7 November 2025

The Secretary
NSW Department of Planning, Housing and Infrastructure

SSD-58978472 Aspect Industrial Estate IVE Printing and Packaging Facility (WH8)

Ground Floor / Site Plan

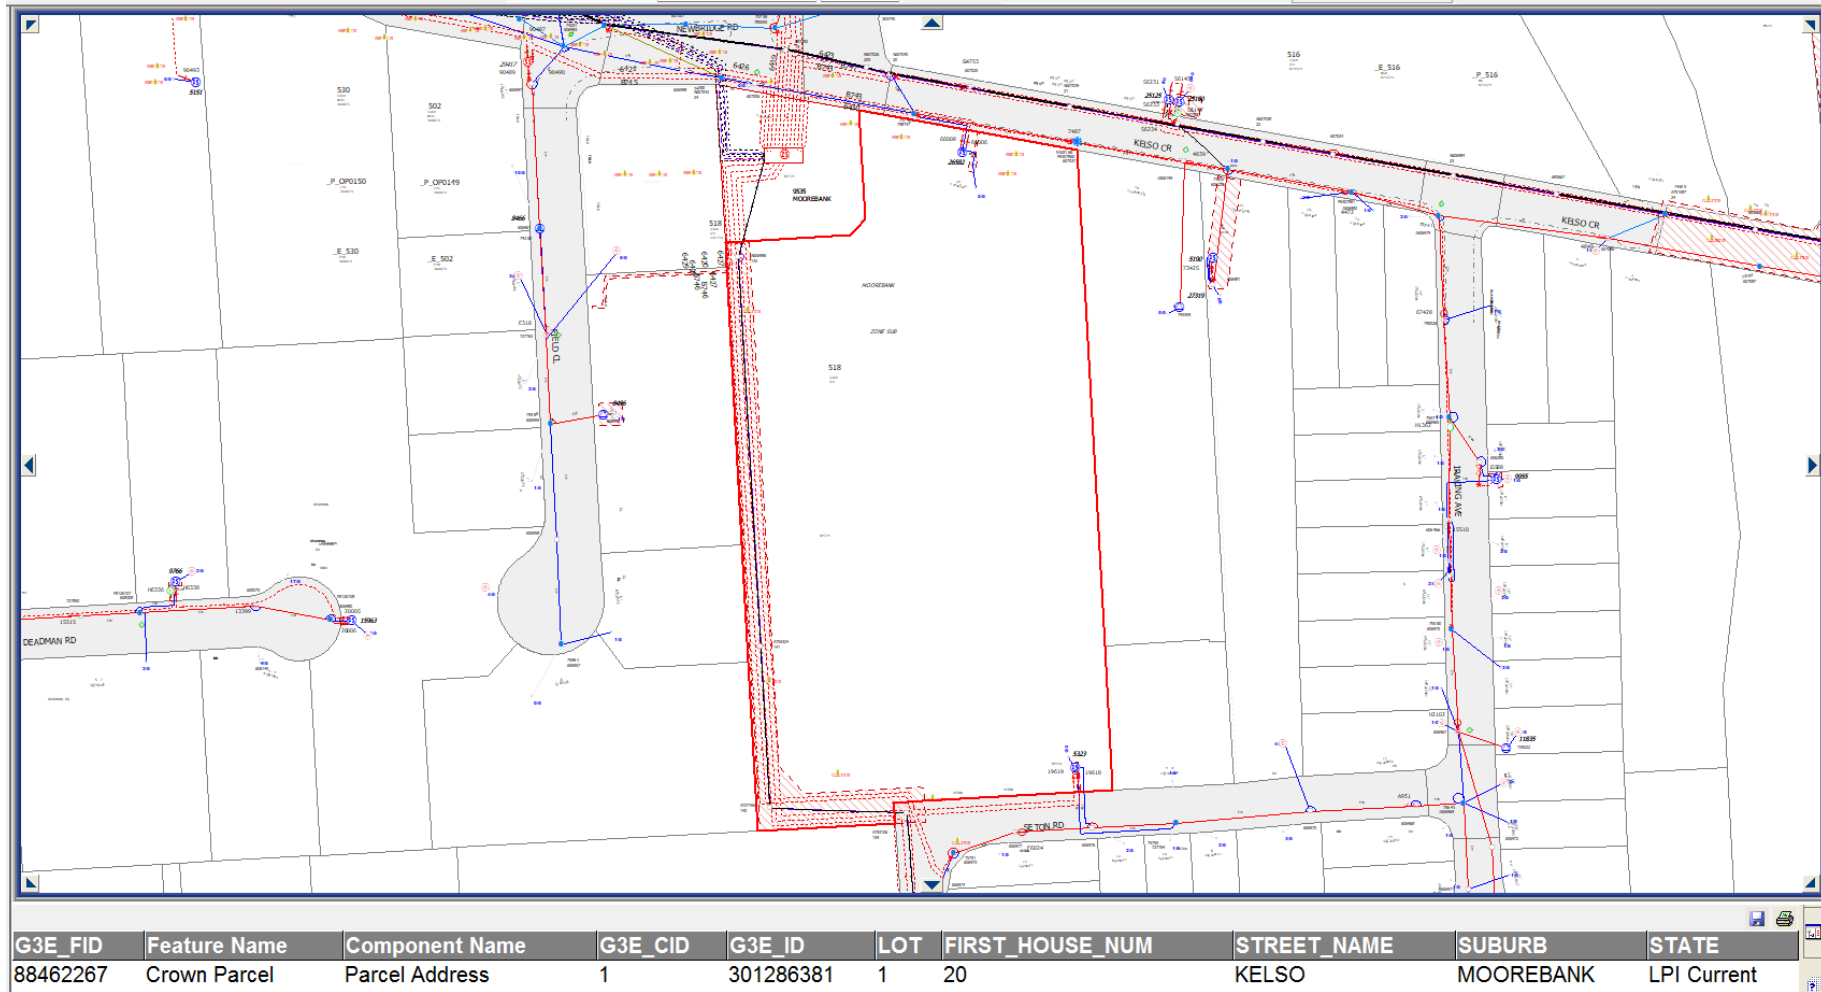
The below copy of the Ground Floor / Site Plan shows provision for three padmount substations and 'Electrical Easement Hatched'.

Any required padmount substation/s will need to be located within the property (in a suitable and accessible location) and be protected (including any associated cabling not located within a public road / reserve) with an appropriate form of property tenure as detailed in the attached copy of Endeavour Energy's 'Land Interest Guidelines for Network Connection'.

Generally it is the Level 3 Accredited Service Provider's (ASP) responsibility (engaged by the developer) to make sure substation location and design complies with Endeavour Energy's standards the suitability of access, safety clearances, fire ratings, flooding etc. If the substation does not comply with Endeavour Energy's standards, the applicant must request a dispensation.
